## FINAL DEVELOPMENT PLAN APPLICATION

Zoning File No. <u>FDP-0057-2023</u>
--------------------------------------

CITY OF GAHANNA - FINAL DEVELOPMENT PLAN  
**CRESCENT WOODS COMMERCIAL**

RE: Project 0 Hamilton Rd Final Development Plan

**SITE PLAN - RESIDENTIAL**

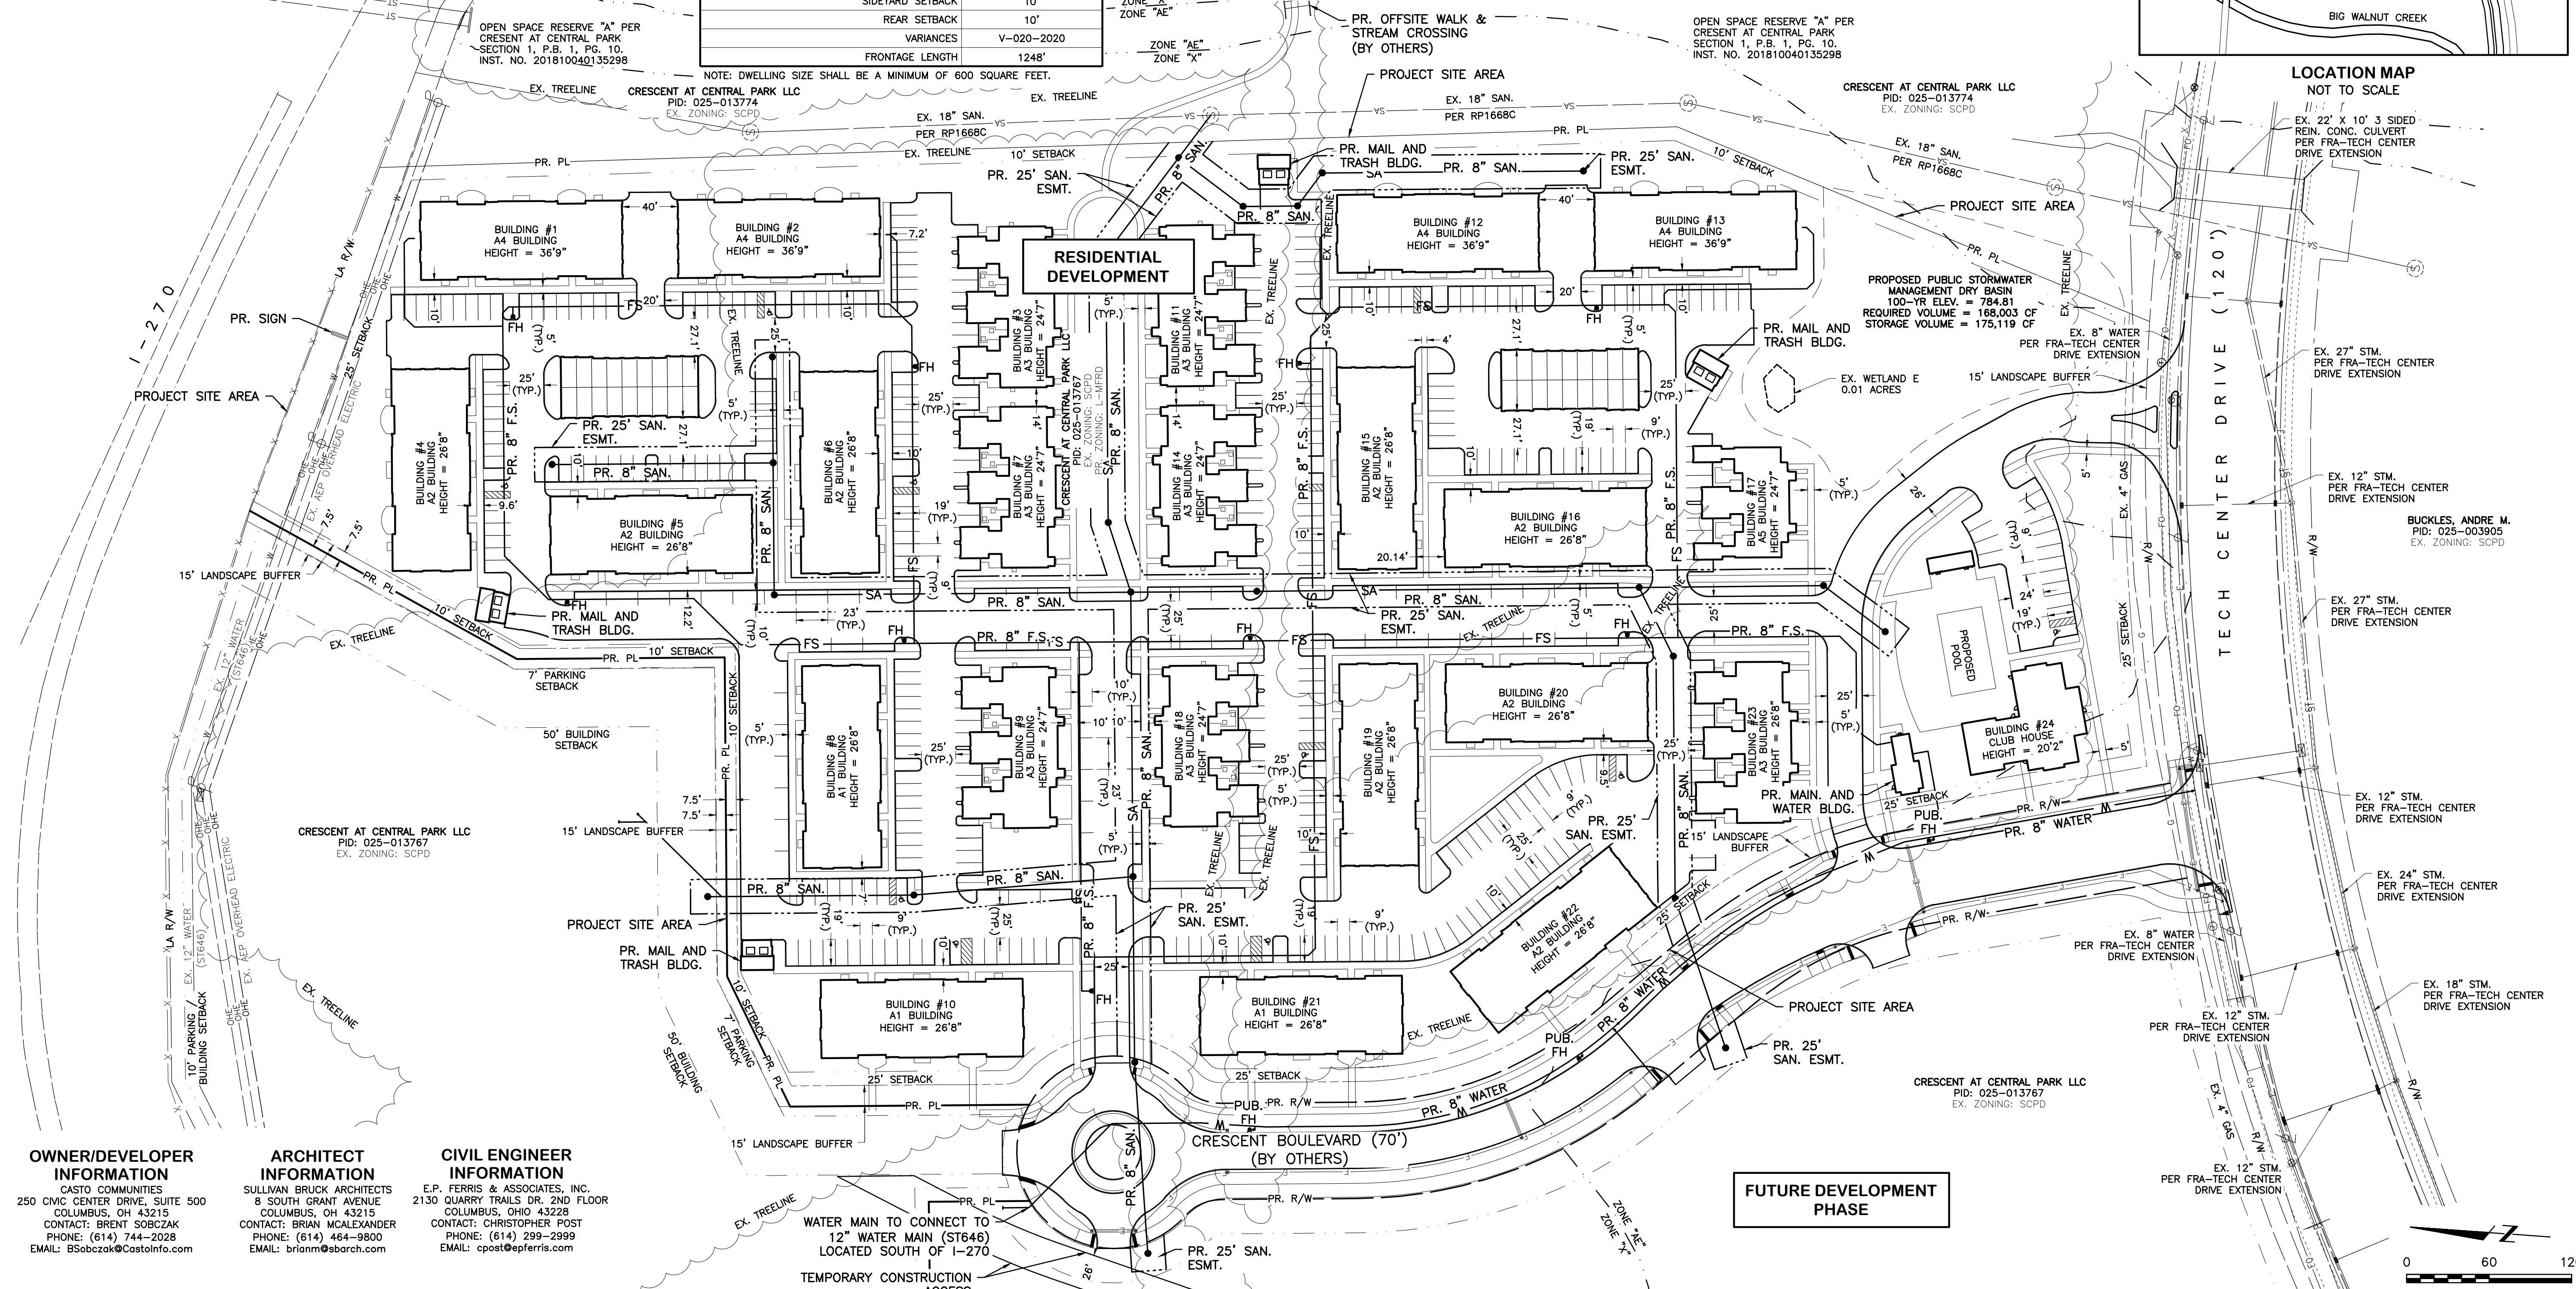
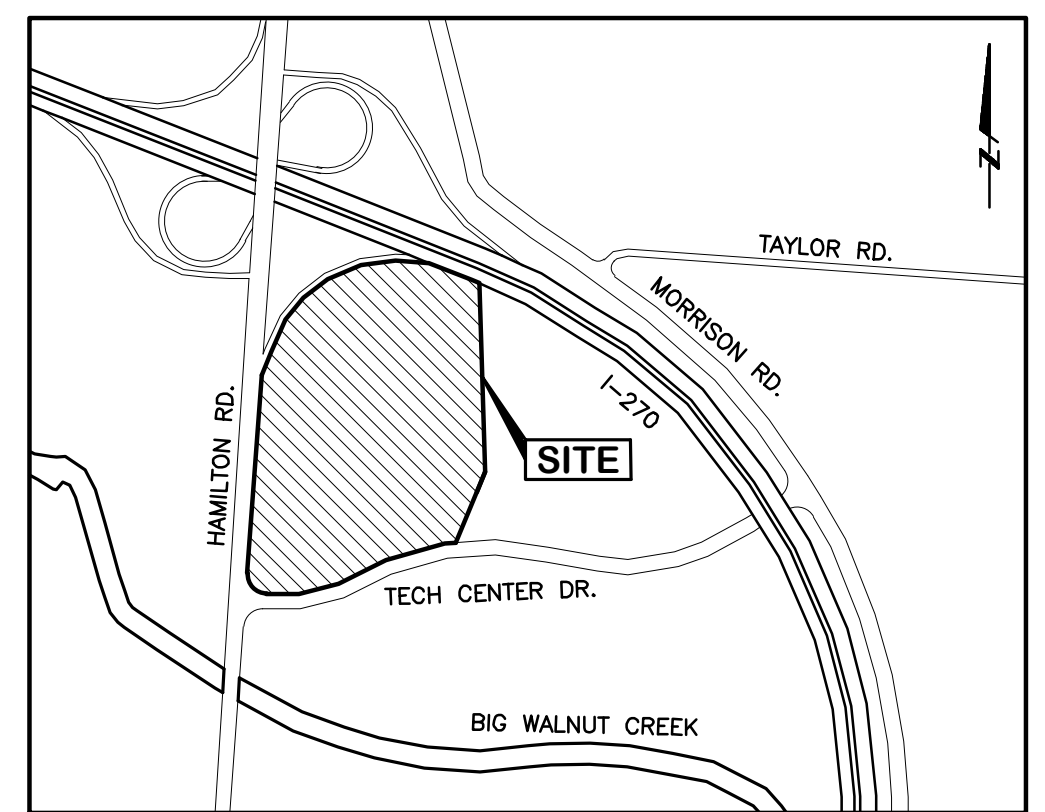
4. Provide documentation showing responsible parties for design and construction of Crescent Boulevard.
5. The parking facilities shown do not appear to be in compliance with Section 208.2.3 of the 2010 ADA Standards for Accessible Design.

1 ENLARGEMENT: DRY BASIN

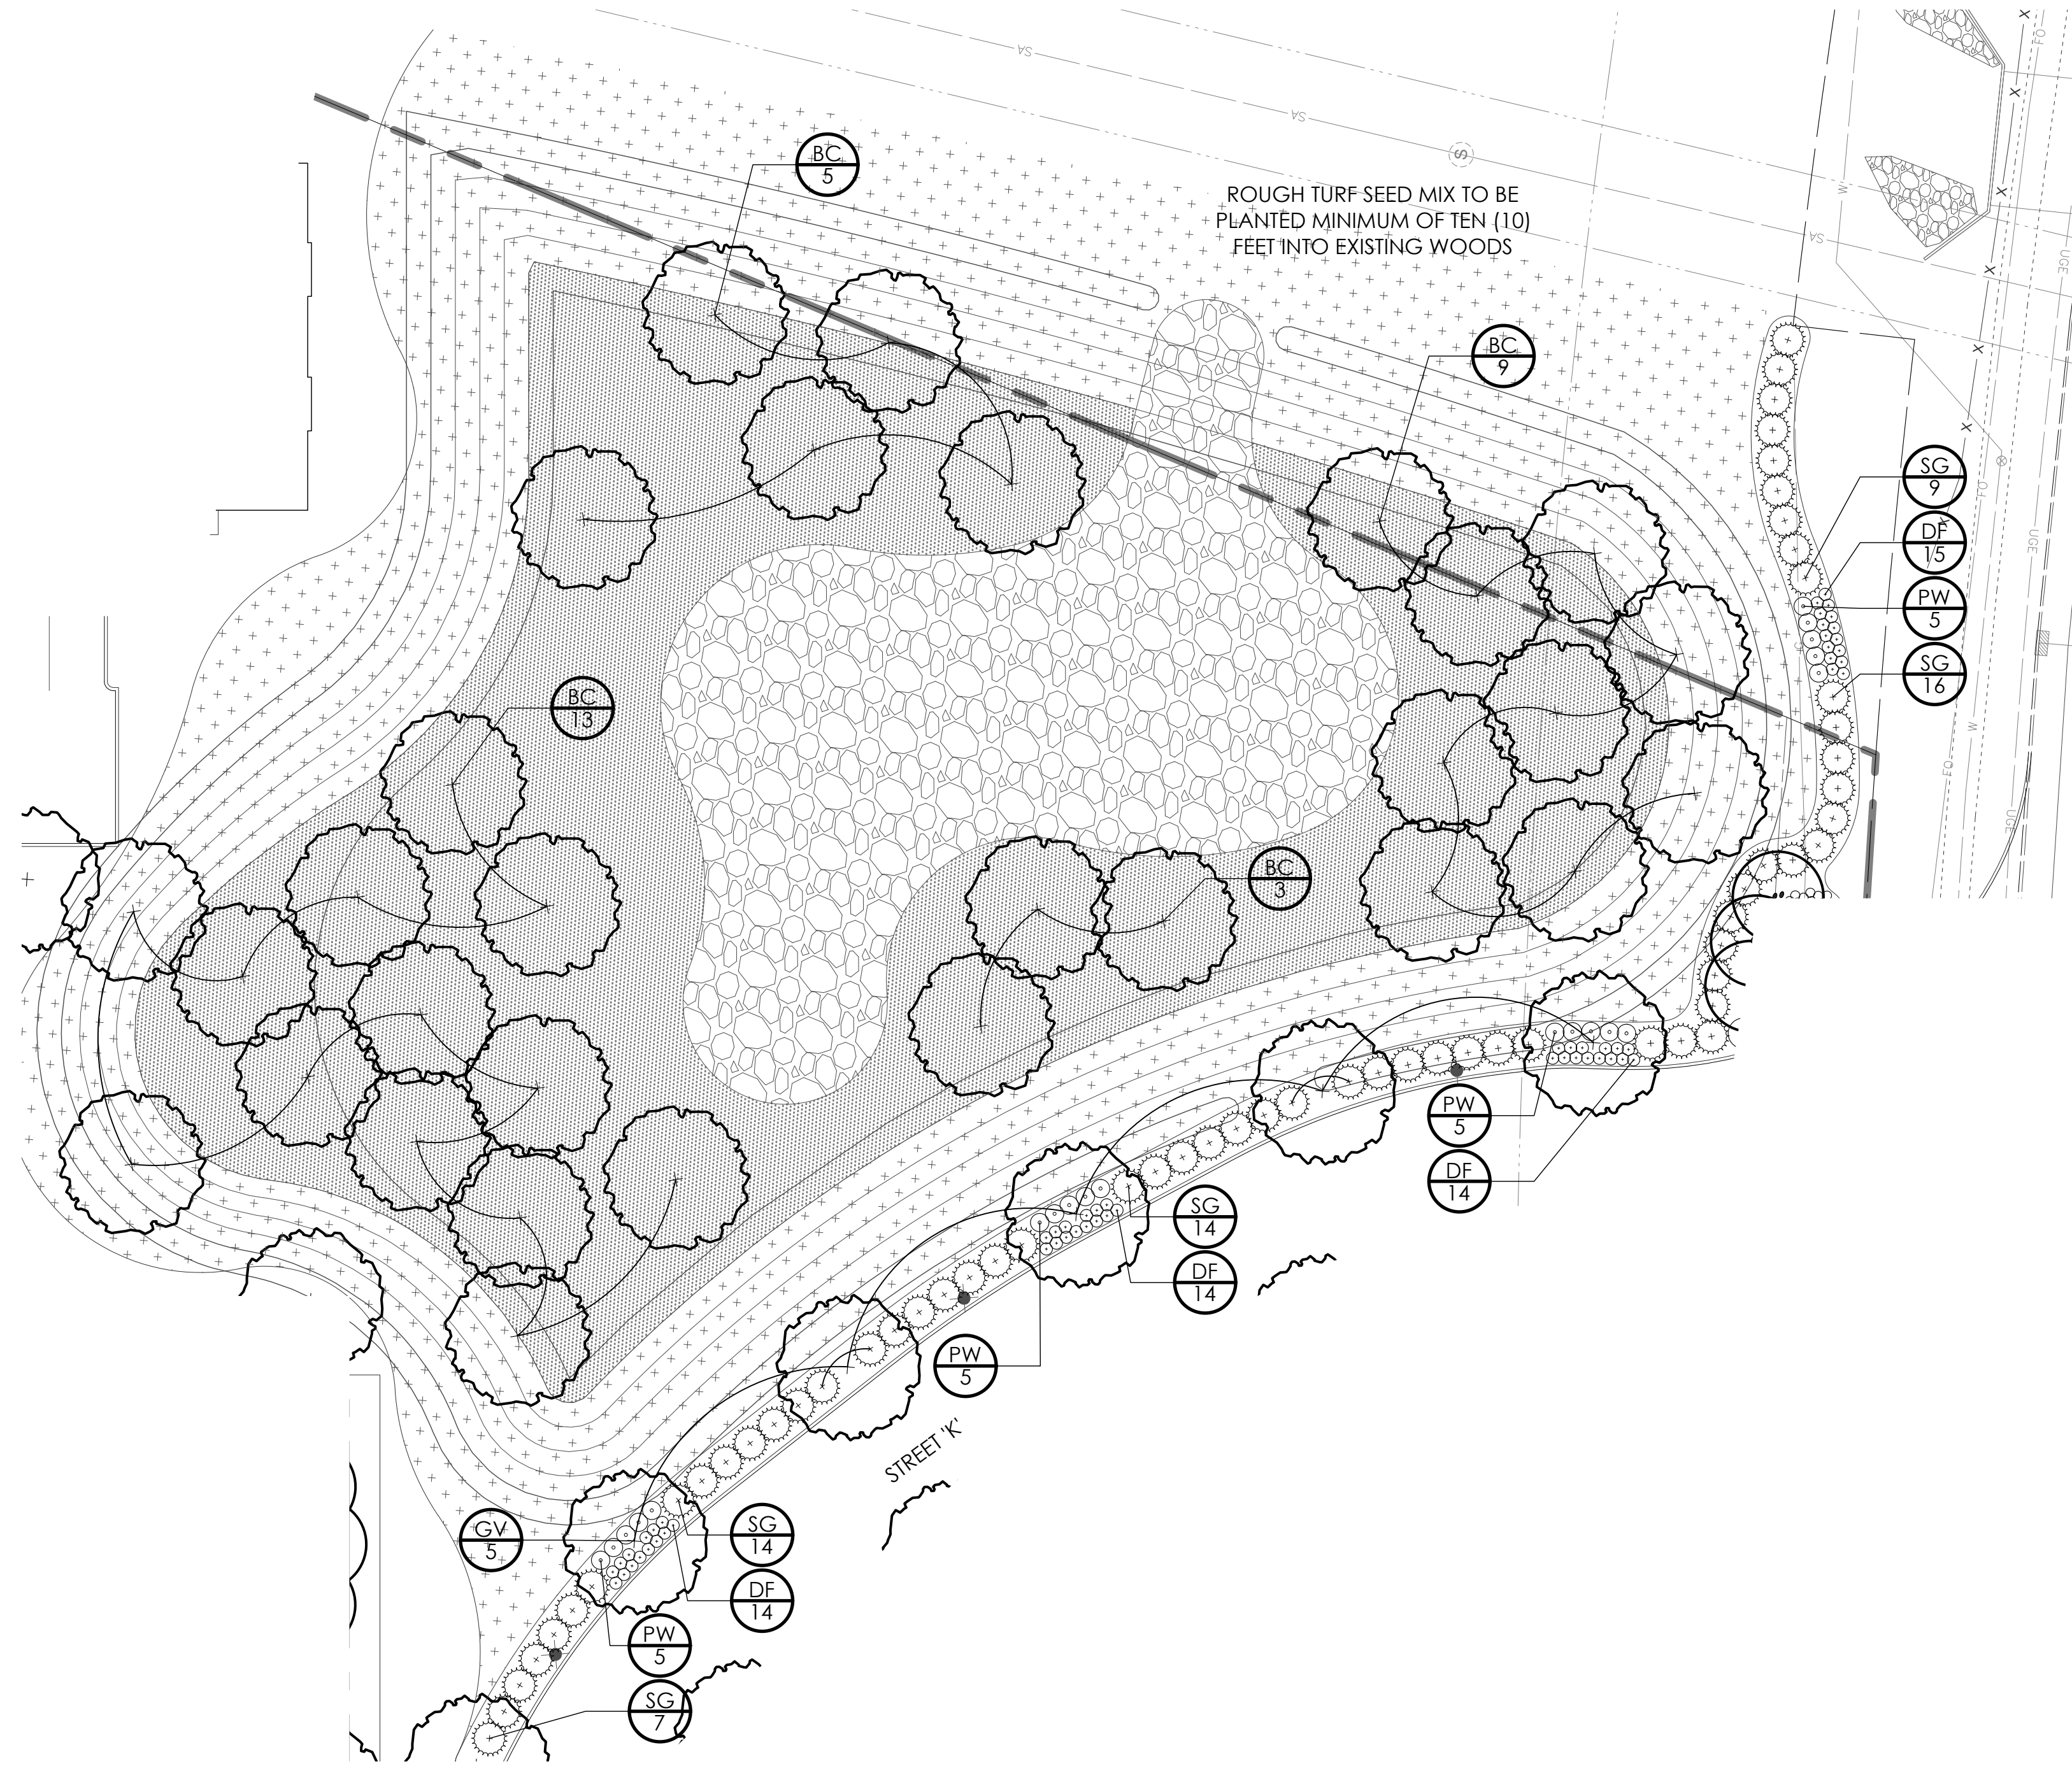
8. Verify drainage basin values (e.g. 100-yr elevation). There is an inconsistency between the stormwater report and plan submittal.

### 3 DECIDUOUS TREE PLANTING

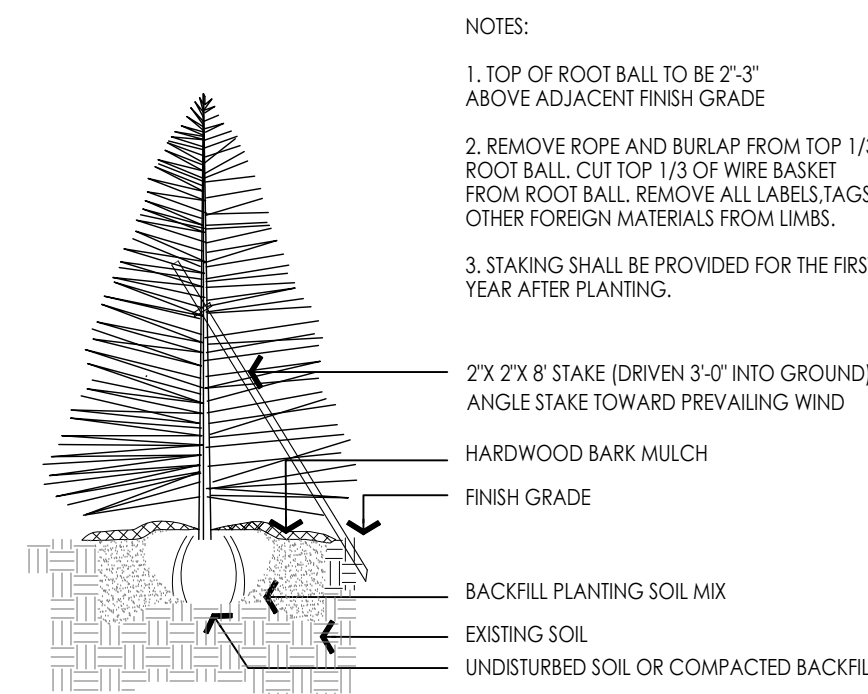
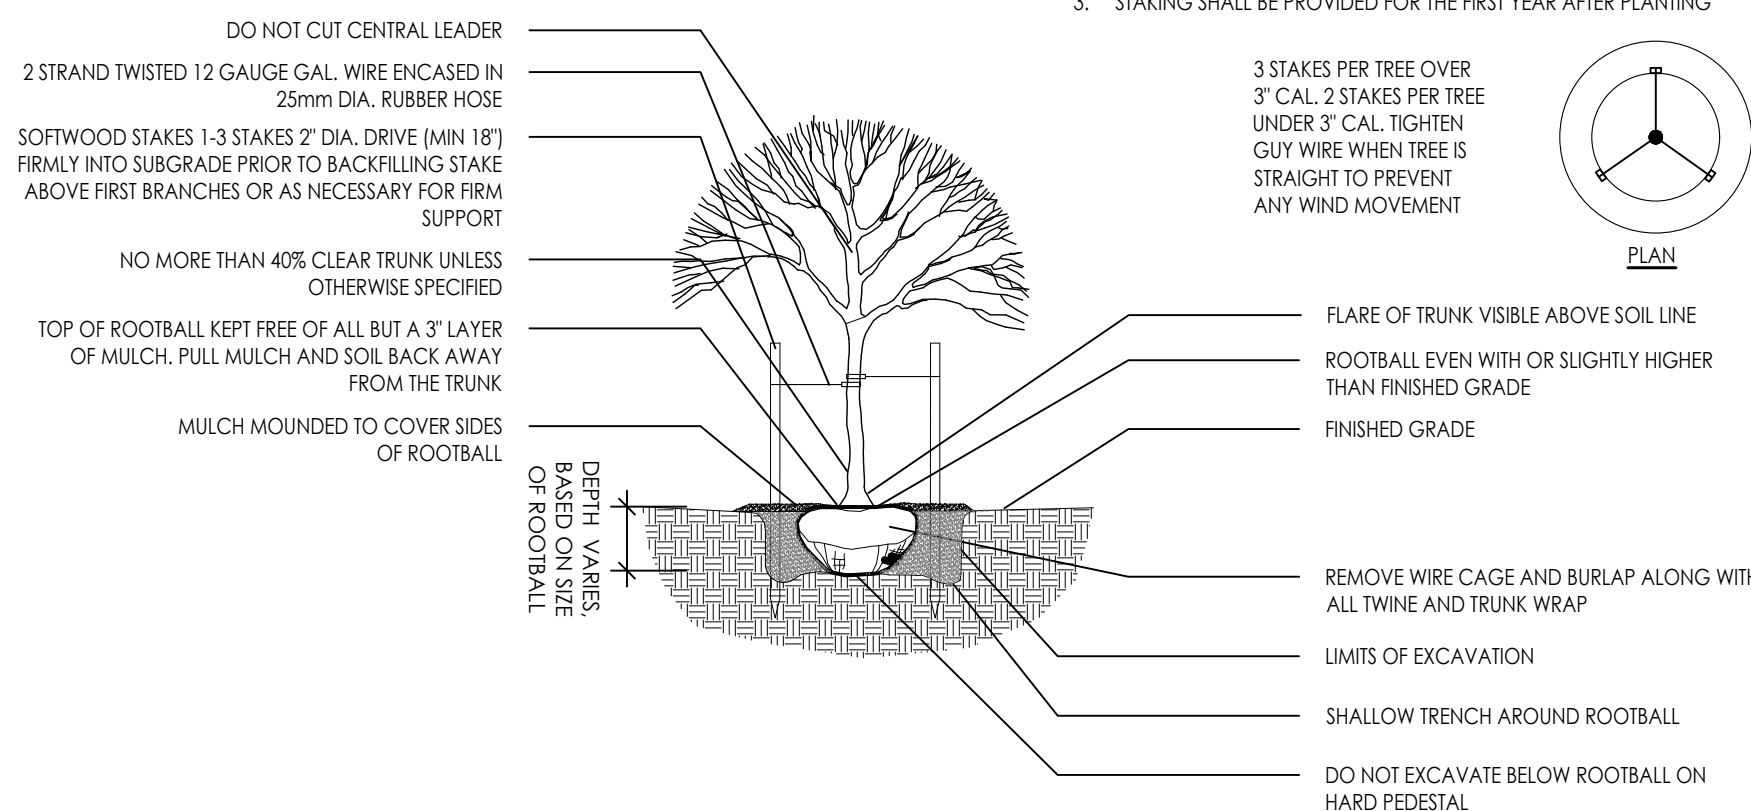
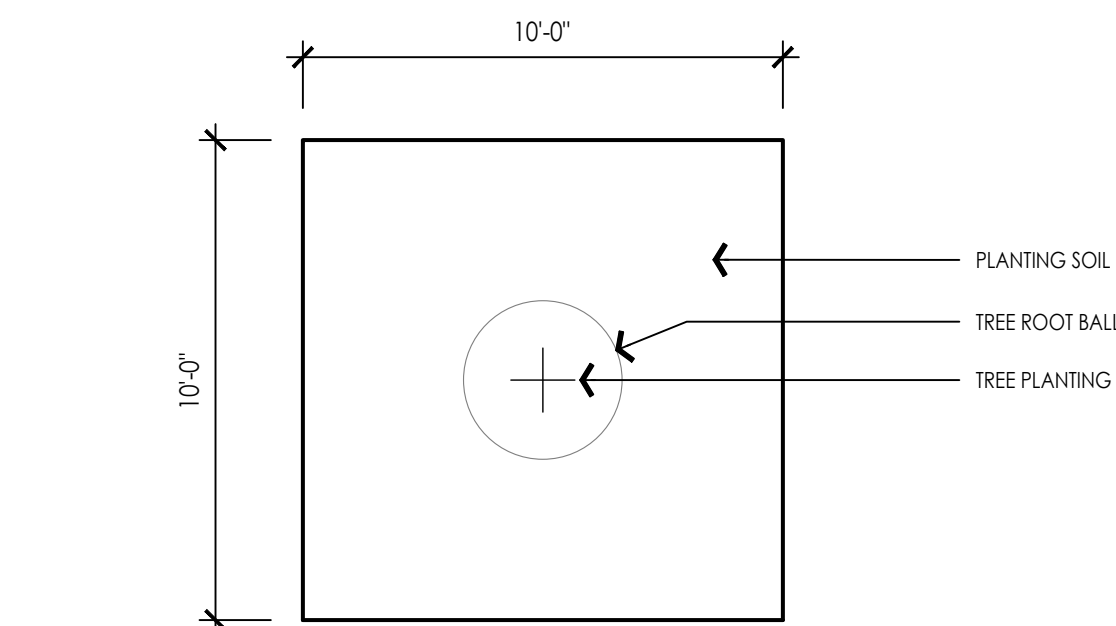
9. Street tree plans must be submitted to Landscape Board (at time of final plat). (*Future Consideration*)
10. Planting notes were updated. In some places, the plans show root flare even with adjacent finish grade. In other places, it says even or slightly above. It is better to plant a tree slightly too high than

slightly too low, but I don't want to see trees intentionally planted too high. After settling, the proper depth is root flare even with adjacent finish grade. *(Informational Comment)*
